Service Bulletin

Bulletin No.: 24-NA-235

Subject: Steering Column Rattle

Brand:	Model:	Model Year:		VIN:		Engine:	Transmission:
		from	to	from	to		
Chevrolet	Colorado	2023	2025	-	-	All	All
GMC	Canyon	2023	2025

6754399

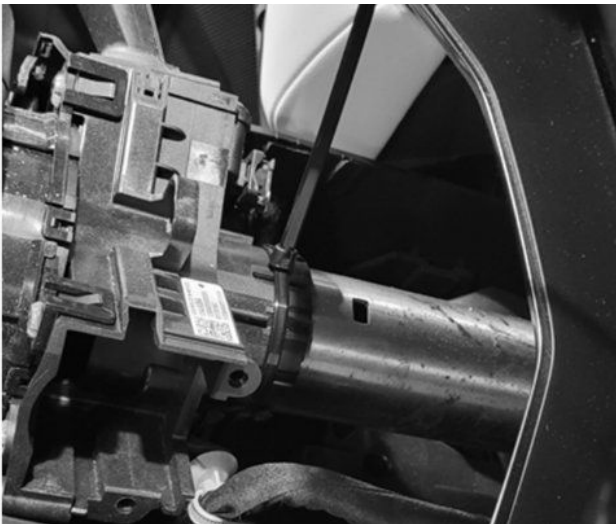
1. Extend the steering column to its furthest point to allow the instrument panel steering column upper trim cover to clear the instrument panel.
2. Using a small plastic trim tool, separate the instrument panel steering column upper trim cover (1) from the instrument panel steering column lower trim cover.

6754400

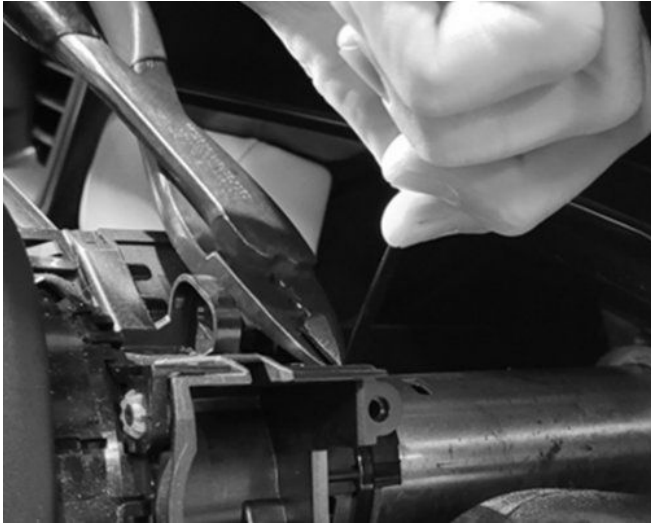
3. Remove the Instrument Panel Steering Column Upper Trim Cover (1)

6754401

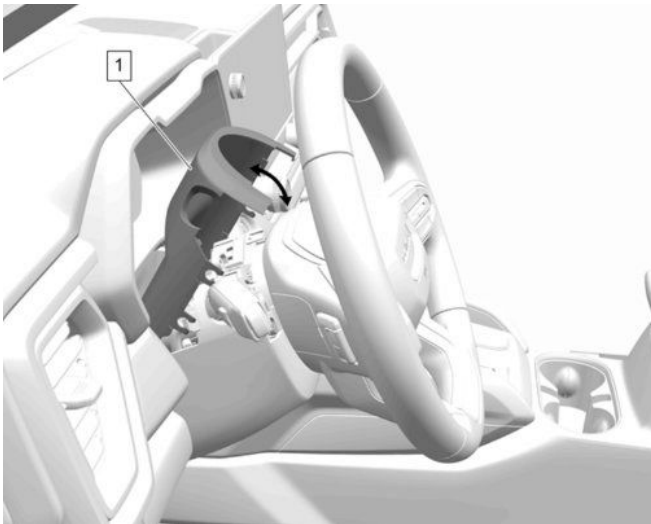
4. Using an appropriate size tie strap, wrap the turn signal mounting bracket and tighten.
